WOLF CREEK NUCLEAR OPERATING CORPORATION

WO 04-0029

Subject: Docket No. 50-482: Revision to Technical Specification (TS)
Figure 3.5.5-1, "Seal Injection Flow Limits"

This amendment application would revise Technical Specification (TS) Figure 3.5.5-1, "Seal Injection Flow Limits," to reflect flow limits that allow a higher seal injection flow for a given differential pressure between the charging discharge header and the Reactor Coolant System (RCS) pressure.

Figure 3.5.5-1 (page 1 of 1)
Seal Injection Flow Limits

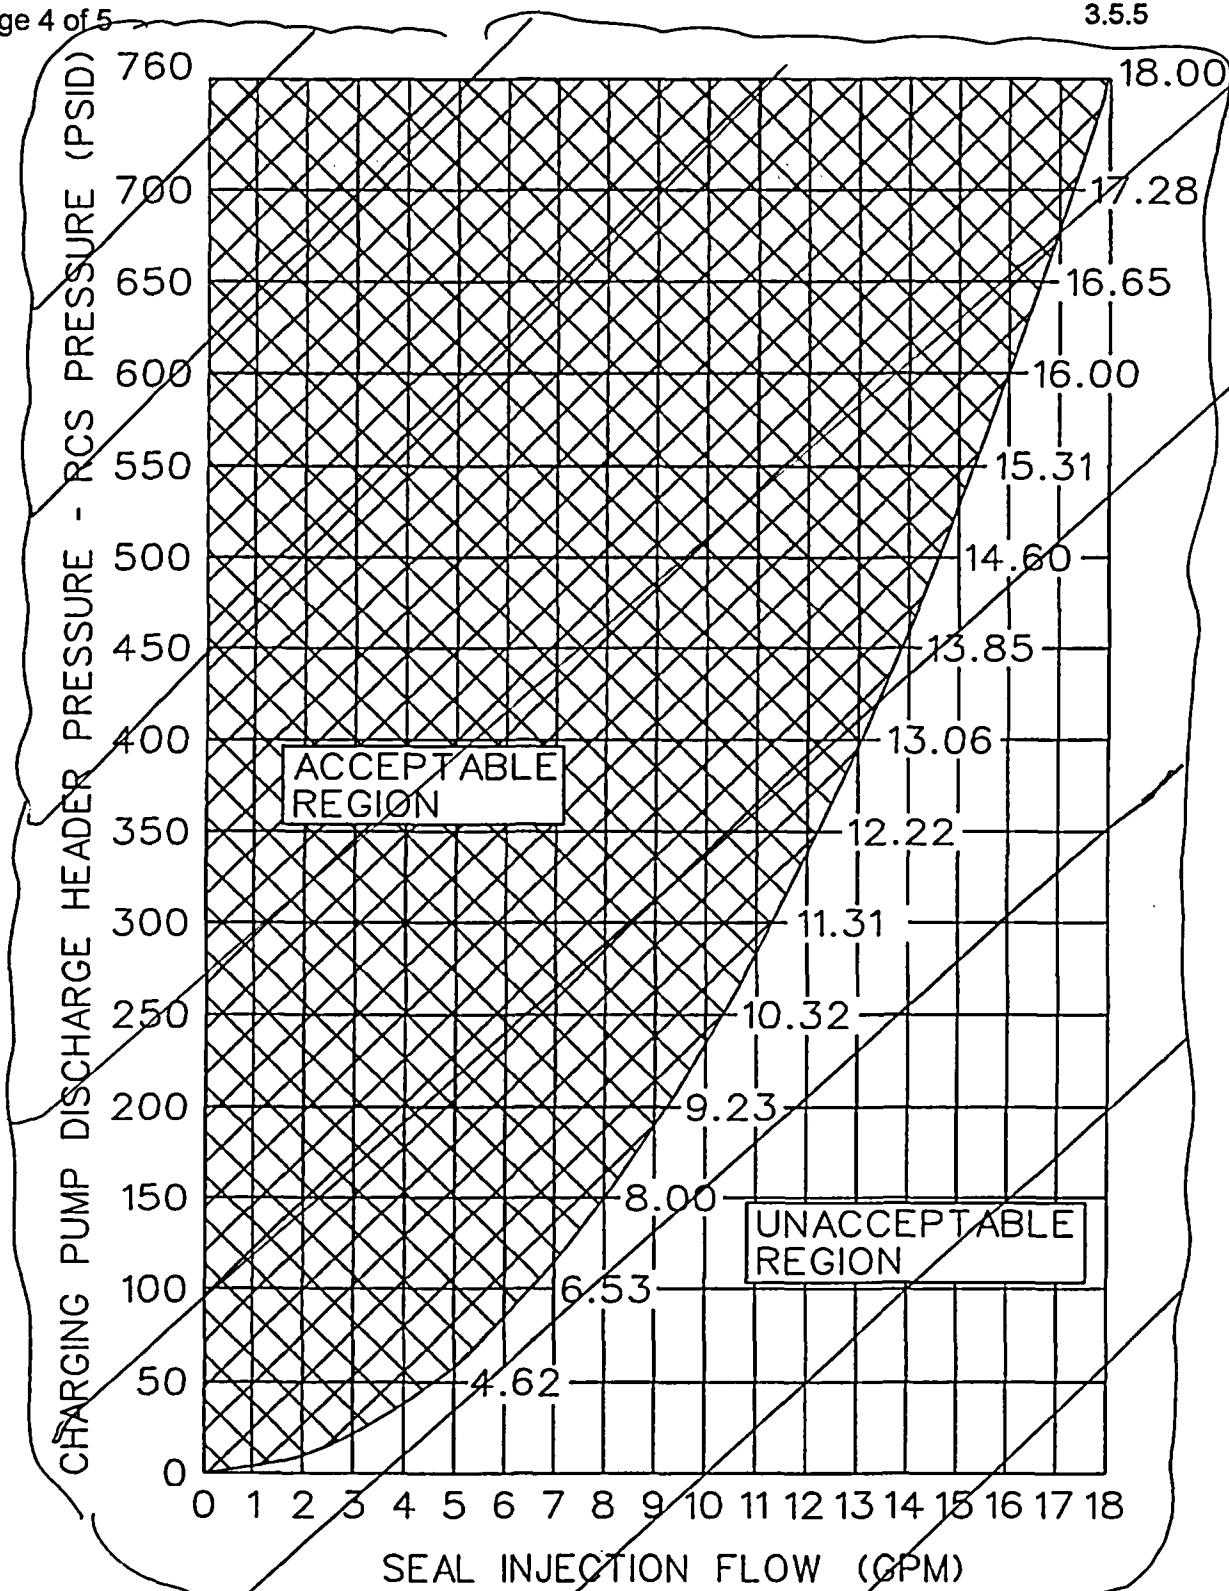
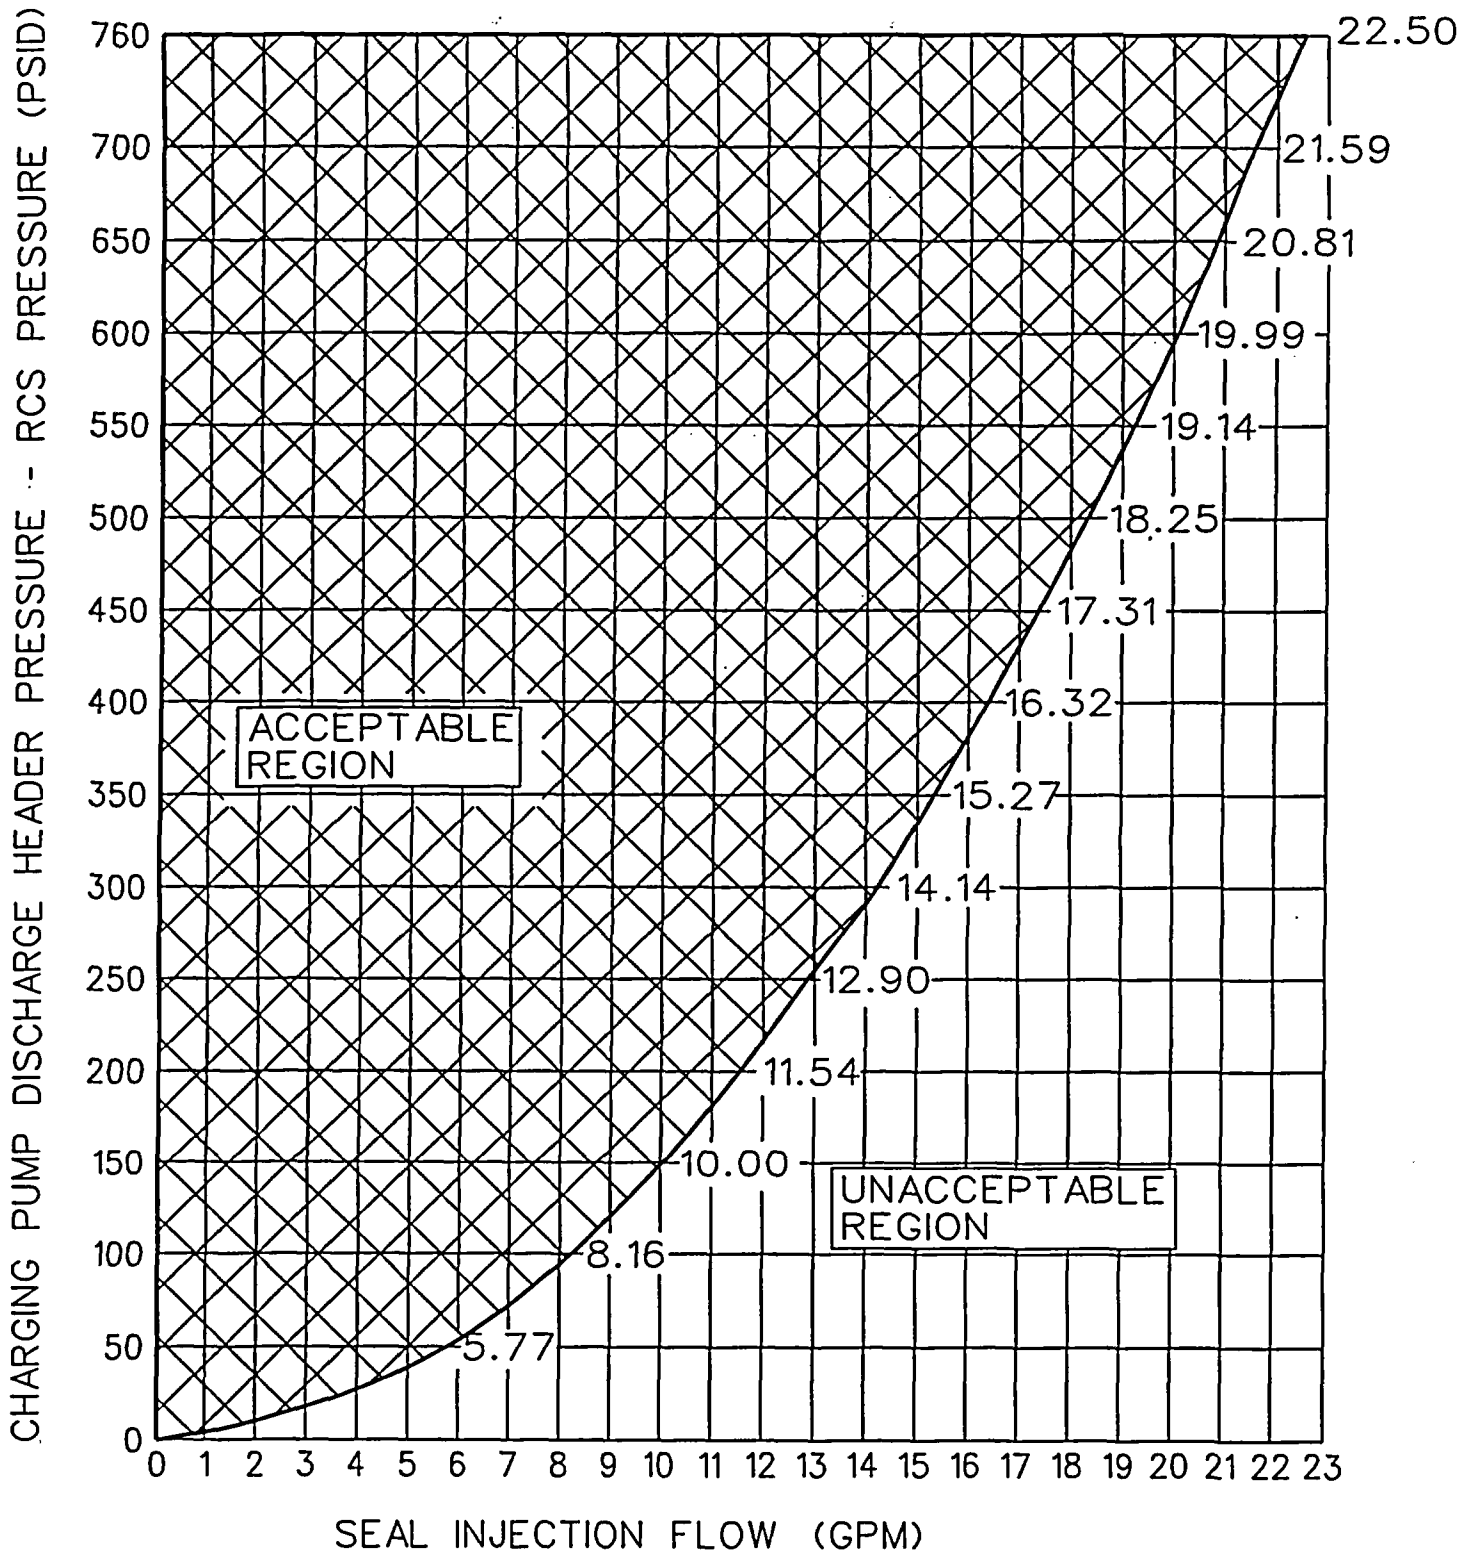
TS Figure 3.5.5-1, "Seal Injection Flow Limits," is being revised to reflect a higher total seal injection flow limit of 90 gpm. The figure is currently based on a total seal injection flow limit of 72 gpm.

INSERT REVISED FIGURE 3.5.5-1

$$Q = \text{SQRT}(0.6661 * DP),$$

Maximum Flow		
Current TS	Proposed TS	DP
8.51	10.64	170
8.64	10.80	175
8.76	10.95	180
8.88	11.10	185
9.00	11.25	190
9.12	11.40	195
9.23	11.54	200
9.35	11.69	205
9.46	11.83	210
9.57	11.97	215
9.69	12.11	220
9.79	12.24	225
9.90	12.38	230
10.01	12.51	235
10.12	12.64	240
